Field campaign

Topic	Mulsanne side view camera control module (SC12/15)
Market area	Bentley: worldwide (2WBE)
Brand	Bentley
Transaction No.	2030874/4
Campaign number	E775
Note	E775
Type	
US code

Figure 1

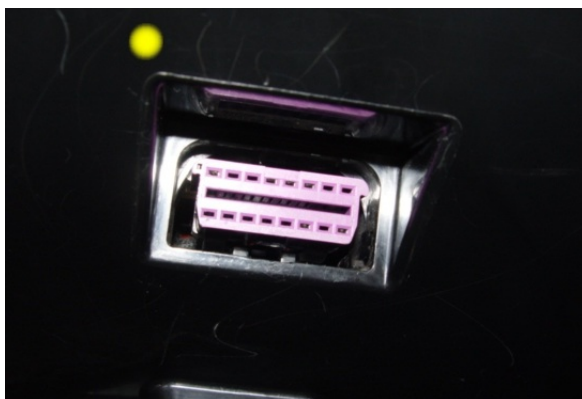
In January 2012 a TPI was released which instructed Dealers to remove where fitted the side view camera control module as a potential fault was identified with the original part. The latest specification side view camera control module is now available for all Bentley Mulsanne vehicles which were specified with the side view camera option. If the original module has been previously removed and replaced with the link loom as per previous instruction, a Yellow paint mark will be evident on the diagnostic plug surrounding cover as shown in Figure 1, please remove the loom and fit the replacement side view camera module as detailed within this document.

Should the vehicle still have the original side view camera module fitted or the link loom was installed at the time of production a Yellow paint mark will not be evident, if this is the case please replace the existing module or remove the link loom and replace with the latest specification part as detailed within this document.

Figure 1

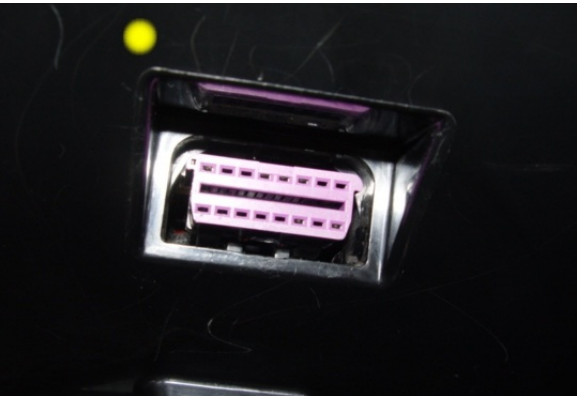
Should the vehicle still have the original side view camera module fitted or the link loom was installed at the time of production a Yellow paint mark will not be evident, if this is the case please replace the existing module or remove the link loom and replace with the latest specification part as detailed within this document.

3. Should the original side view camera control module have been previously removed and replaced with the link loom 3Y0 998 381 there should be a Yellow completion paint mark on the diagnostic plug surrounding cover (Figure 1), please carefully remove this and replace with a White paint completion mark as shown in Figure 2. If the original control module has been replaced for the latest specification part or the factory fitted loom has been replaced with the latest specification part, a White paint completion mark should also be added (Figure 2)
